ADDENDUM '02'

Project Name Collingwood Green Phase 3
Toledo, Ohio

Addendum Date: February 13, 2017

A
A502

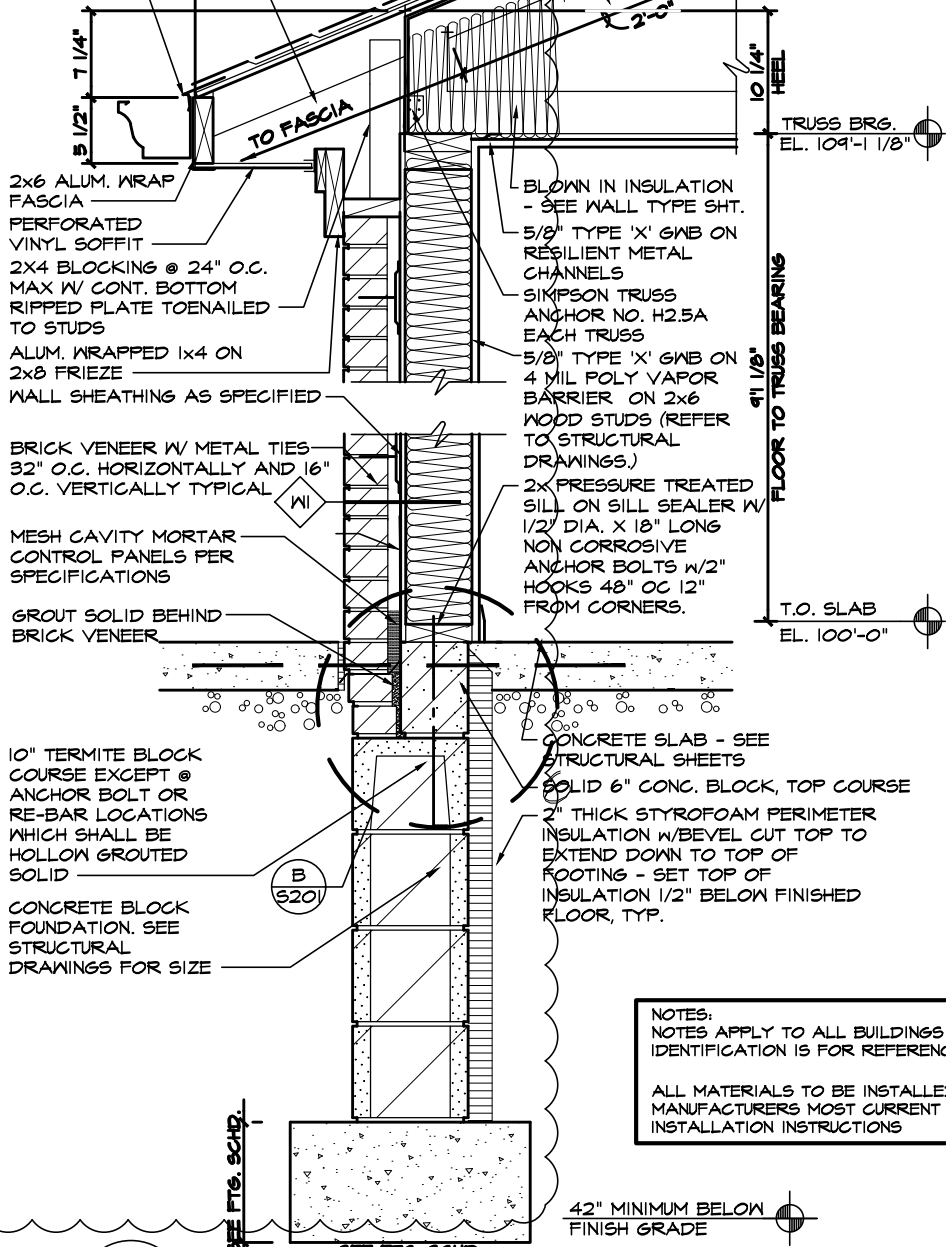
19. Sheet A502
 - a. Detail A/A502: Revised building section to match roof framing plan S102F.
20. Sheet A602
 - a. Revise wall section D/A602 to be full height brick veneer. See attached sketch

D
wall section
A606
3/4" = 1'-0"

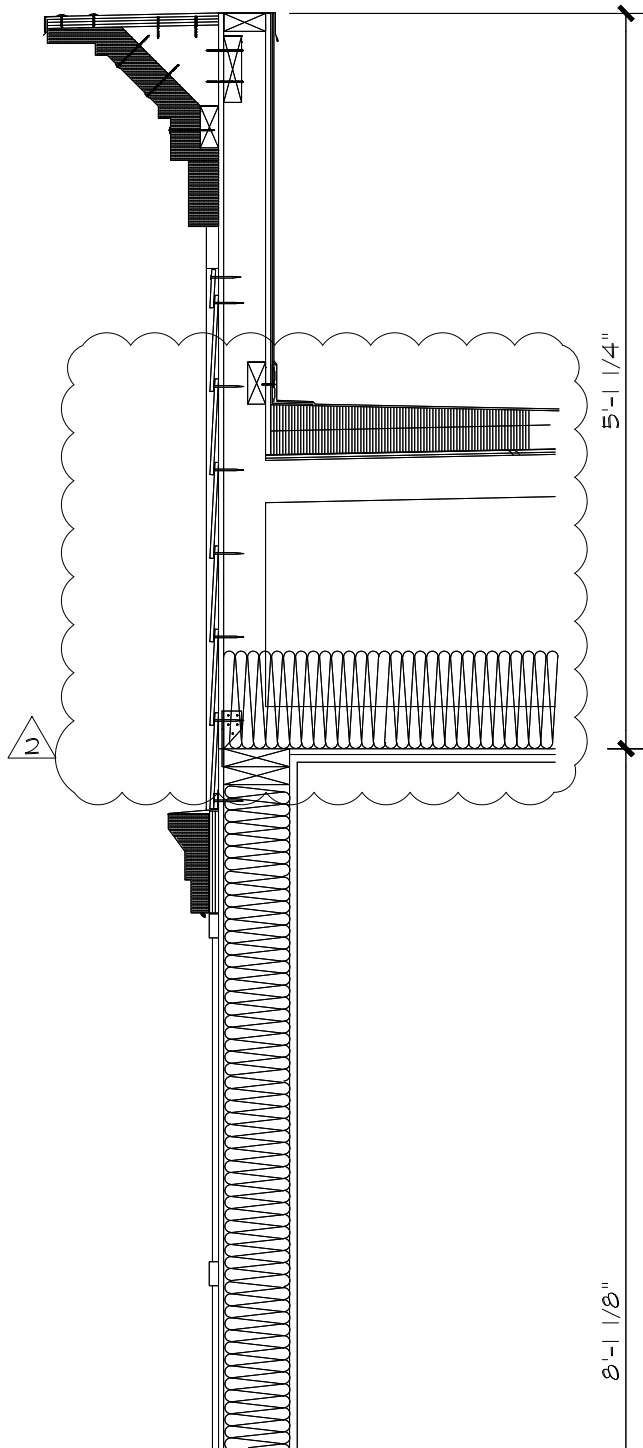
22. Sheet A606
 - a. Revise direction of joists in section H/A606
 - b. Revise direction of joists and roof slope in section D/A606
 - c. Add scupper, add call out for window detail and revise roof joists in section E/A606. See attached sketches.

G wall section
A606
3/4"=1'-0"

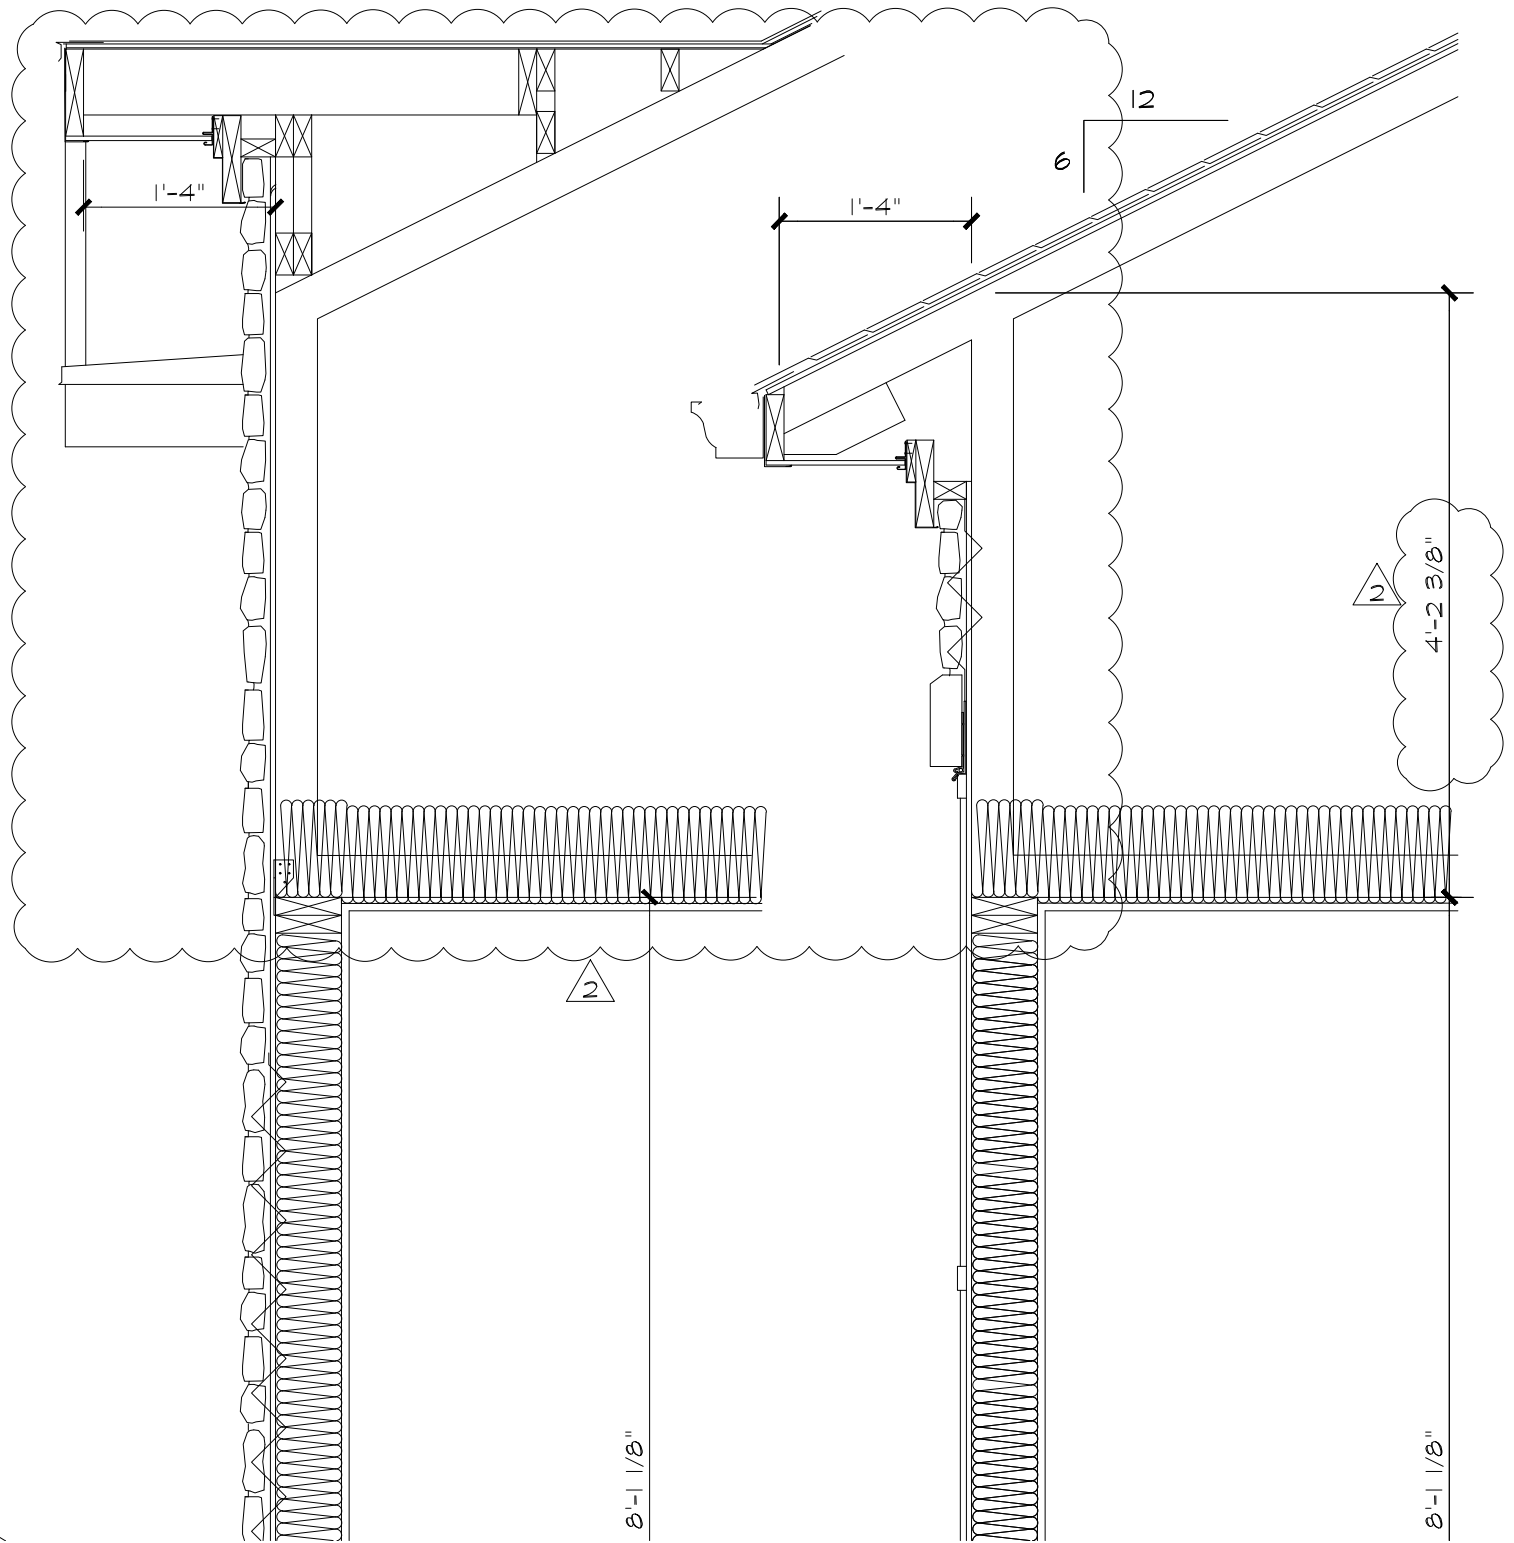
- d. Revise roof framing on G/A606. See attached sketches.
- 23. Sheet A607
 - a. Revise roof truss in section G/A607
 - b. Revise roof slope note in section D and E/A607 to read “ SEE ROOF PLAN FOR ROOF SLOPE” (Not included in sketches)

A wall section
A607
3/4" = 1'-0"

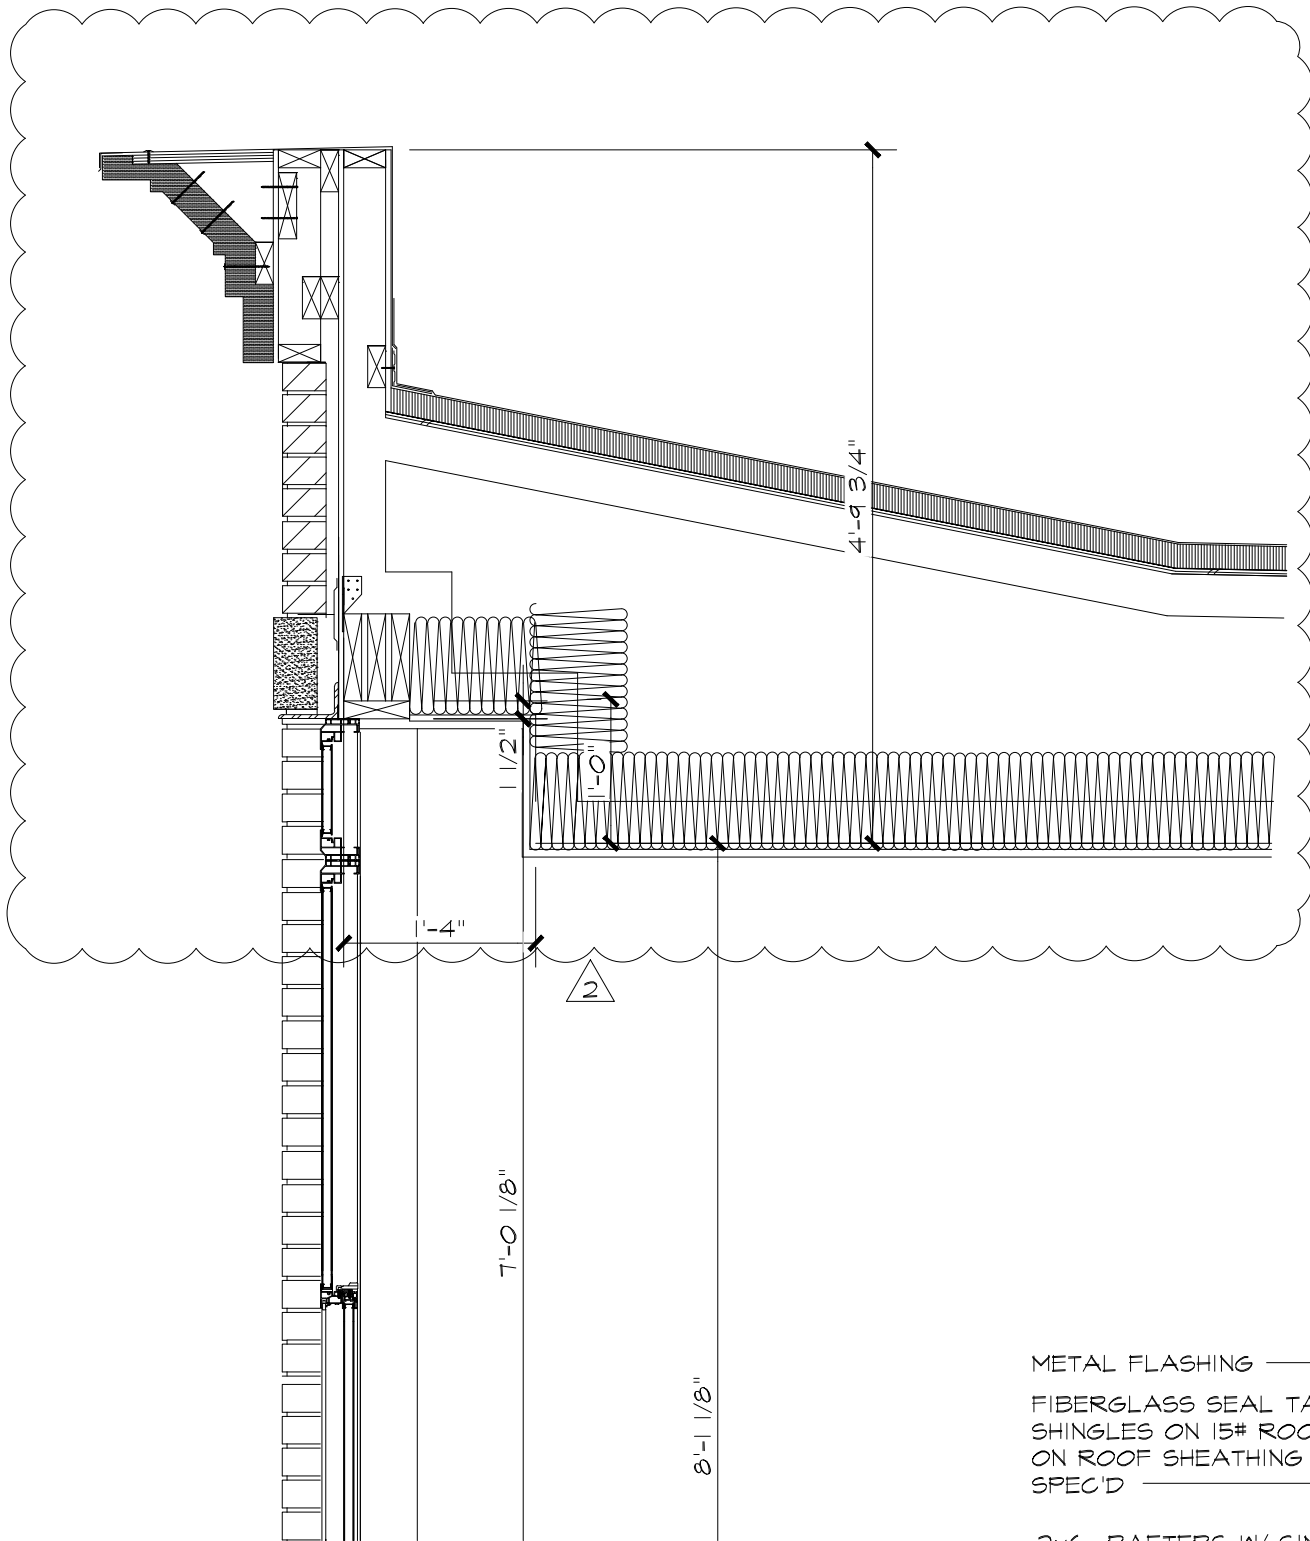
- c. Add 'sim' notation to detail call out on section C/A607 (not included in sketches)
 - d. Revise roof framing and add eave trim on section B/A607
 - e. Add dimension and eave trim on section A/A607. See attached sketches.

E wall section
A608 $3/4" = 1'-0"$

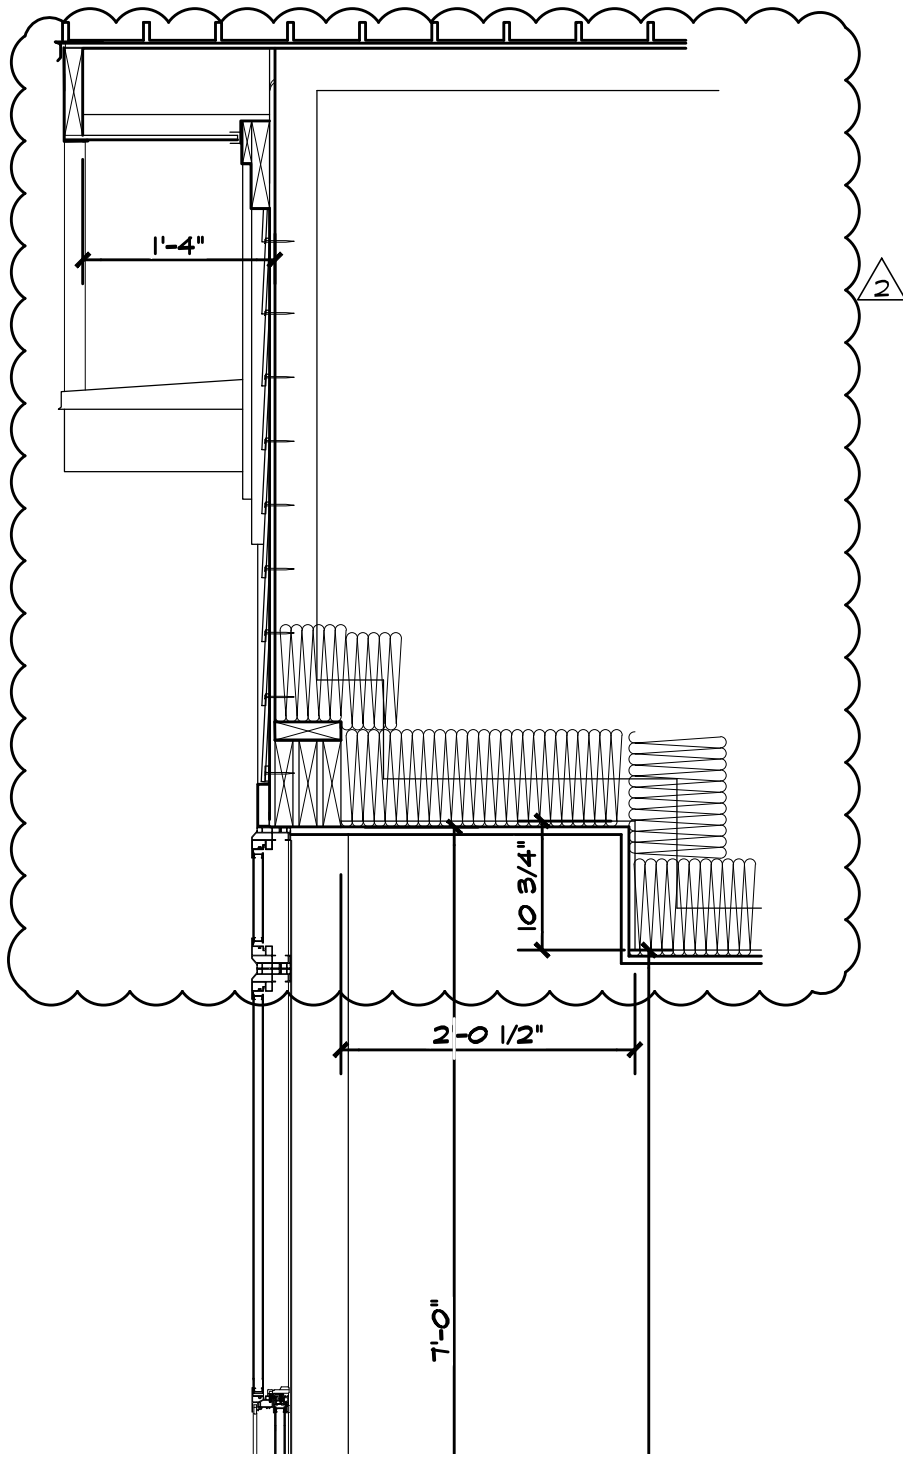
- 24. Sheet A608
 - a. Add eave trim and revise roof framing in section A/A608
 - b. Revise roof framing on section E/A608
 - c. Revise parapet on section D/A608. See attached sketches.

F wall section
 A609 3/4"=1'-0"

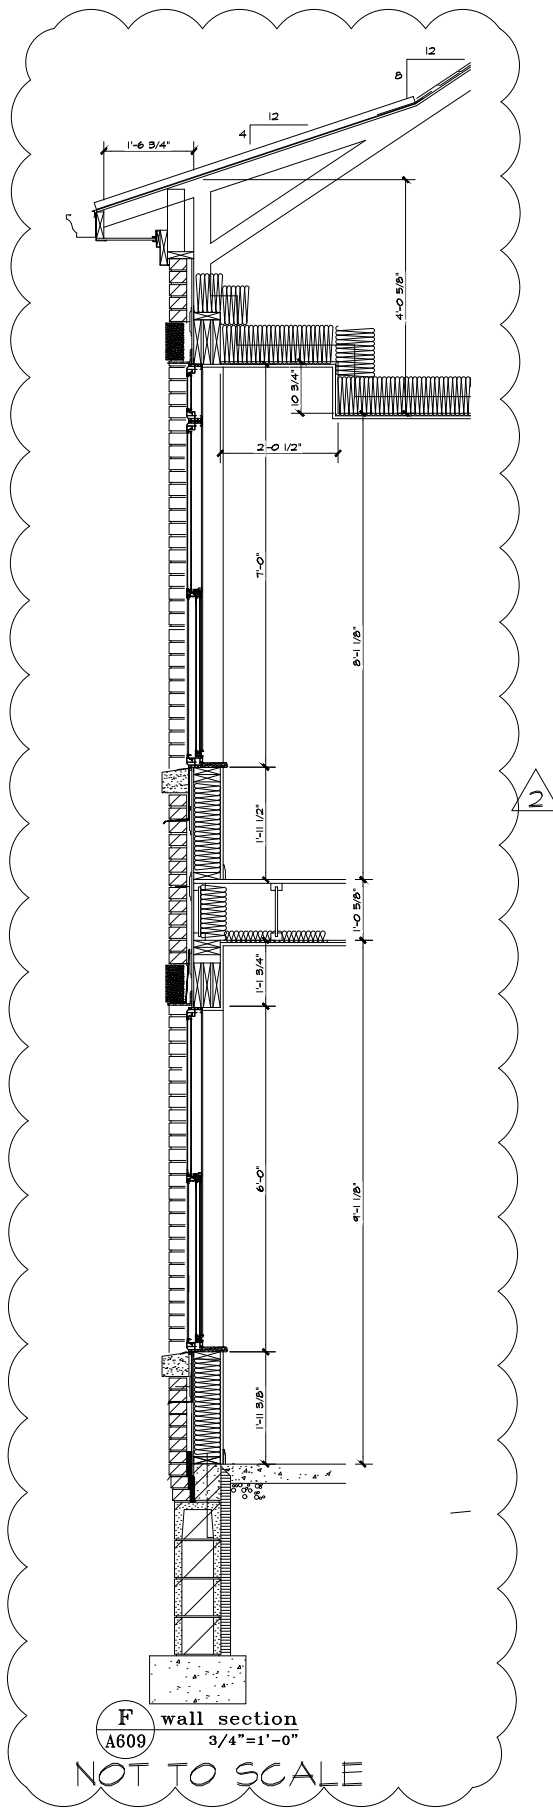
- 25. Sheet A609
 - a. Revise roof framing on section A/A609, B/A609 and F/A609.
 - b. Add section F/A609. See attached sketches.
- 26. Sheet A610
 - a. Revise roof framing in sections A, B, E and F/A610

G wall section
A614 3/4"=1'-0"

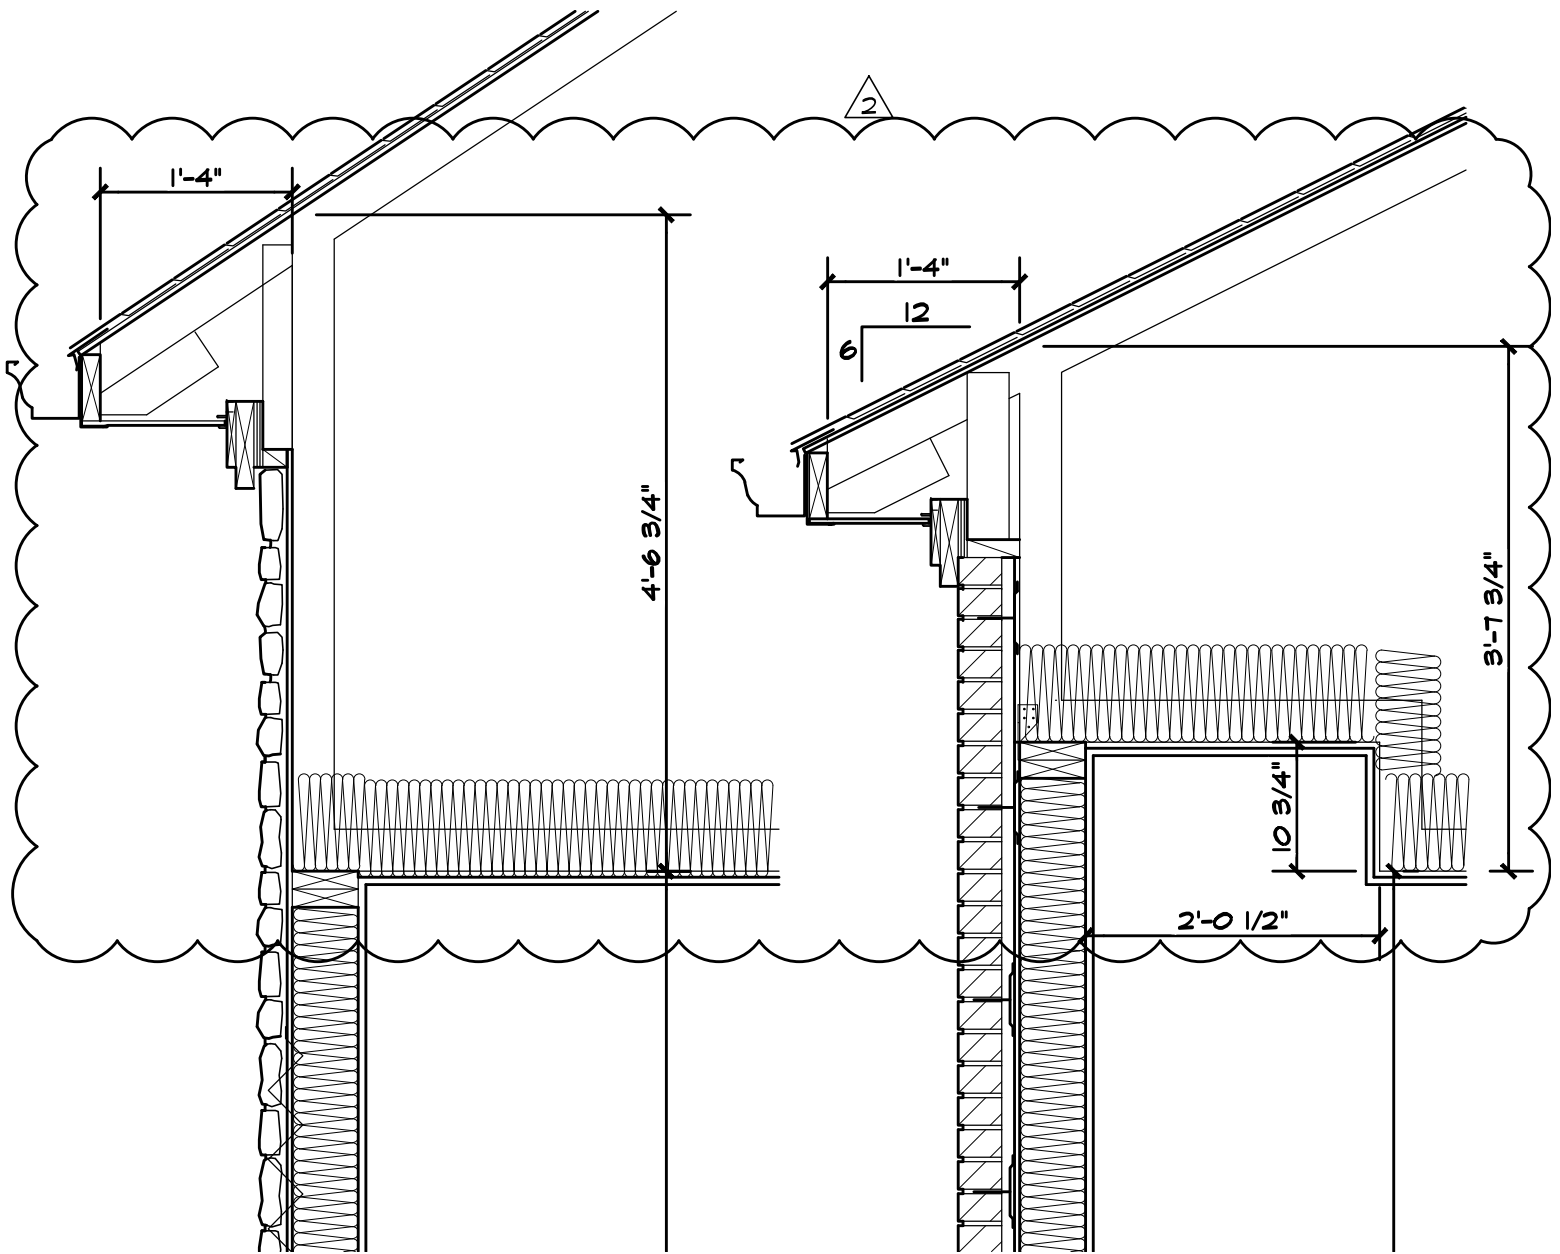
- b. Revise roof and floor framing on sections E and F/A614
 - c. Revise stone veneer, roof framing, window height and window trim on section G/A614
 - d. Revise window height and window trim on section H/A614. See attached sketches.
